Technical Bulletin

Push/Pull Anchor Bracket Modifications to Mount on a Similar Width Sideshifter

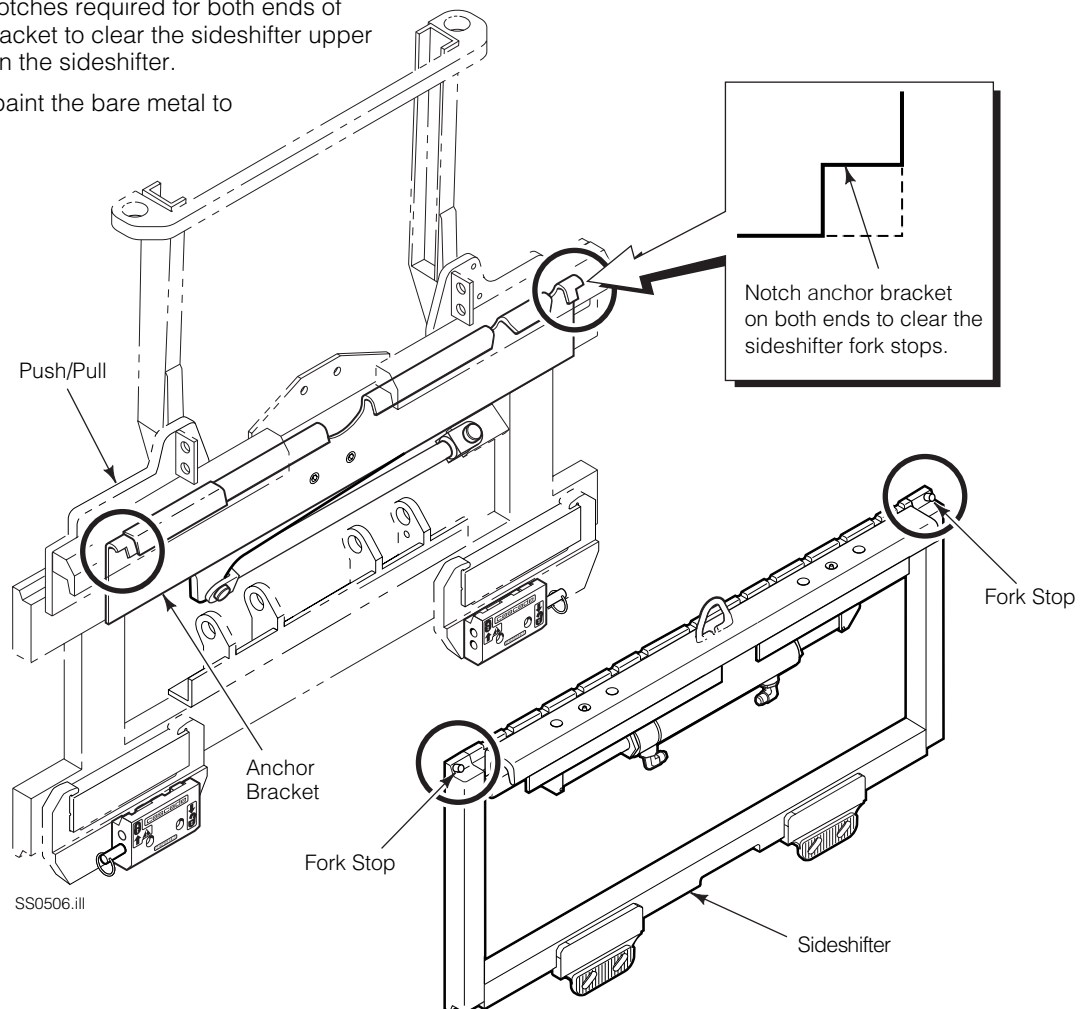
This sheet describes how to modify a sideshifter to mount on a truck carriage that is the same width. The ends of the cylinder bracket need to be notched to clear the carriage fork stops.

- 1 Remove the anchor bracket from the Push/Pull.
- 2 Determine the size of notches required for both ends of the Push/Pull anchor bracket to clear the sideshifter upper fork stops and lay flat on the sideshifter.
- 3 Grind the notches. Repaint the bare metal to prevent corrosion.
